# Access Compliance Report

## Public Rights-of-Way

### (Curb Ramps)

Intersection ID: 44118	Main Street: CORAM_PL	Cross Street: RIDING_HILL_AV	Location: SW
ADA ID: BC3B716A4577	Ramp Type: PerpDiag	Initial Pass/Fail: Fail	Overall Compliance: No
Severity Score: 46.25			
Codes/Mitigation Info/Possible Solution		Field Measurements/Component Compliance

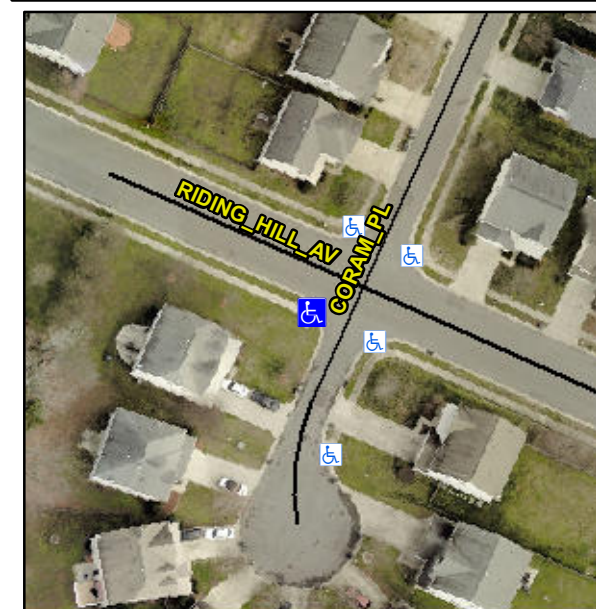
**Remove & Replace Curb Ramp With Two New Directional Ramps or Equivalent.**

**Not Found, R304.5.1, R304.2.2, R304.5.3**

Compliance	Description	Data	Compliance	Description	Data
N/A	Ramp Length (in)	48.0	No	Ramp Slope (%)	11.4
No	Ramp Width (in)	38.0	No	Ramp XSlope (%)	7.1
N/A	Flare Type LT	N/A	N/A	Flare Type RT	N/A
N/A	Flare Slope LT (%)	N/A	N/A	Flare Slope RT (%)	N/A
N/A	Flare Traversable LT?	N/A	N/A	Flare Traversable RT?	N/A
N/A	Landing Length (in)	N/A	N/A	DWS Provided?	N/A
N/A	Landing Width (in)	N/A	N/A	DWS Contrast?	N/A
N/A	Landing Slope (%)	N/A	N/A	DWS Length (in)	N/A
N/A	Landing X Slope (%)	N/A	N/A	DWS Full Width?	N/A
N/A	Landing Curb? (Y/N)	N/A	N/A	DWS Offset (in)	N/A
N/A	Shared Landing?	N/A			
N/A	Gutter Ponding?	N/A	N/A	Gutter Slope (%)	N/A
N/A	Gutter Lip Ht (in)	N/A	N/A	Gutter X Slope (%)	N/A
N/A	Painted X Walk1?	No	N/A	Painted X Walk2?	No
	X Walk 1 Direction	To SE		X Walk 2 Direction	To NE
N/A	X Walk 1 Width (in)	N/A	N/A	X Walk 2 Width (in)	N/A
	X Walk 1 Slope (%)	0.7		X Walk 2 Slope (%)	2.2
	X Walk 1 X Slope (%)	3.5		X Walk 2 X Slope (%)	4.6
